UNITED STATES
NUCLEAR REGULATORY COMMISSION
WASHINGTON, D.C. 20555-0001

LICENSEE: Tennessee Valley Authority

FACILITY: Browns Ferry Nuclear Plant, Units 1, 2, and 3

SUBJECT: SUMMARY OF FEBRUARY 15, 2017, MEETING WITH TENNESSEE VALLEY AUTHORITY ON UPDATES TO THE TRANSMISSION SYSTEM REGARDING EXTENDED POWER UPRATE FOR BROWNS FERRY NUCLEAR PLANT, UNITS 1, 2, AND 3 (CAC NOS. MF6741, MF6742, AND MF6743)

1. List of Attendees
2. Charts - Existing Voltage Regulation and New Voltage Regulation

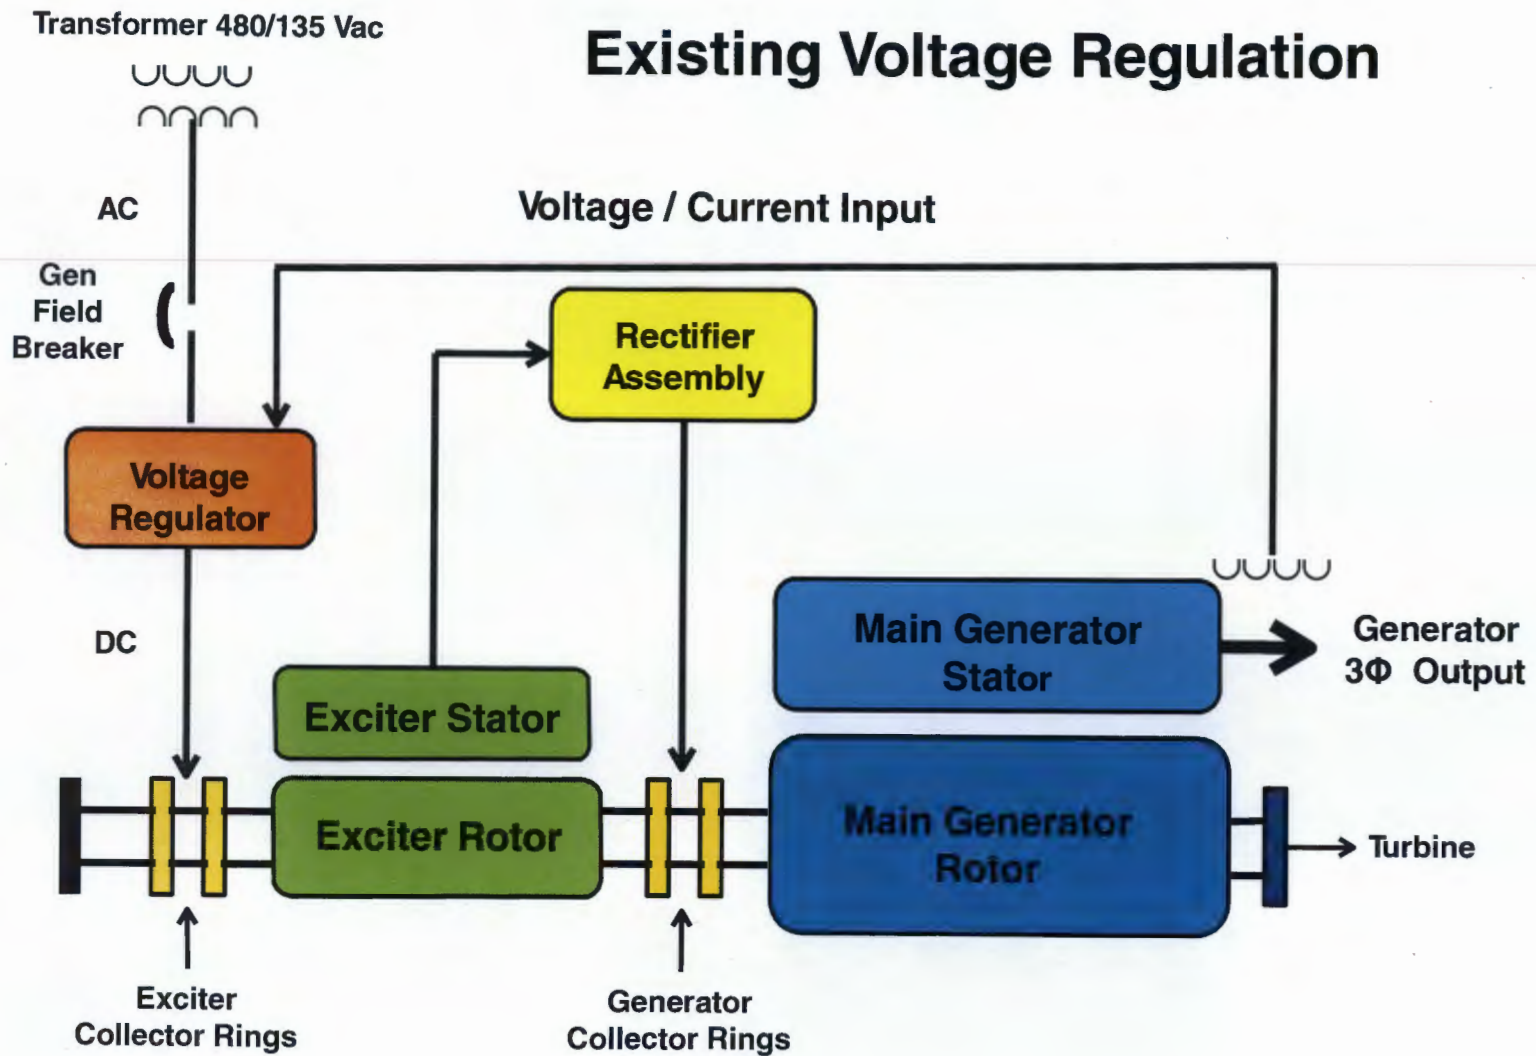
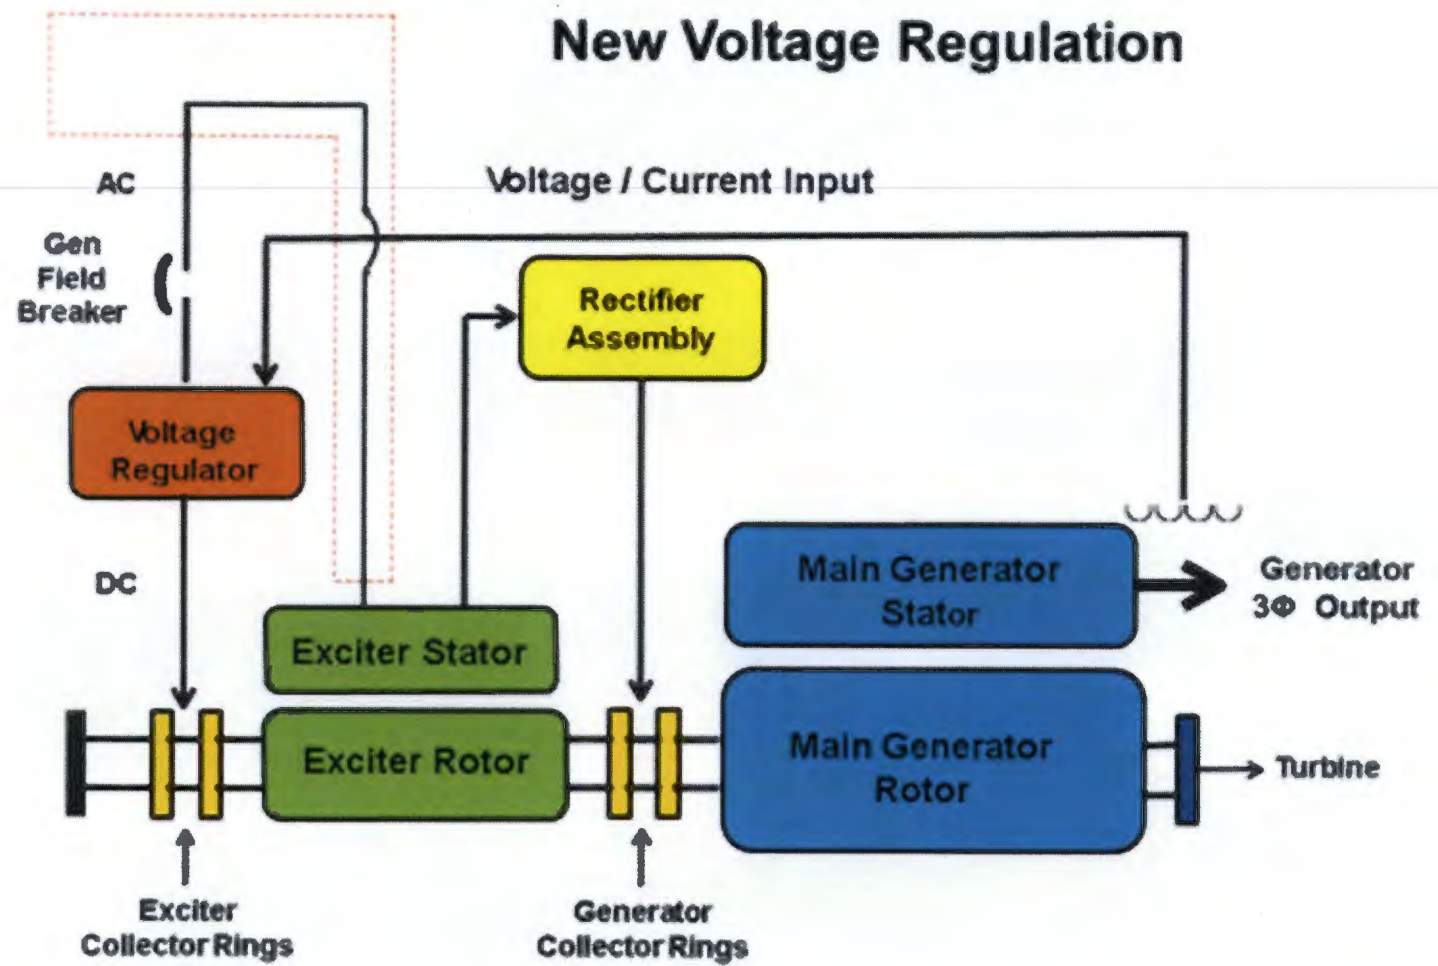
The NRC staff asked clarifying questions throughout the presentation. Specifically, the NRC staff asked the licensee to provide the values (before the error and after correcting the error) of the generator field parameter affected by the identified legacy error. The licensee provided the requested information by an e-mail where the licensee explained that the open circuit transient time constant value was the generator field parameter affected by the identified legacy error. A value of 7.283 seconds was reported after the 2003 Stator rewind versus a 2016 corrected value of 9.273 seconds. Both of these numbers are at the 1,330-million volt-ampere rating. Additionally, during the presentation, the NRC staff asked TVA to provide a block diagram of the existing generator exciter system and the proposed modified generator exciter system. The licensee, in another e-mail, provided the requested diagrams as shown in Enclosure 2 of this meeting summary.
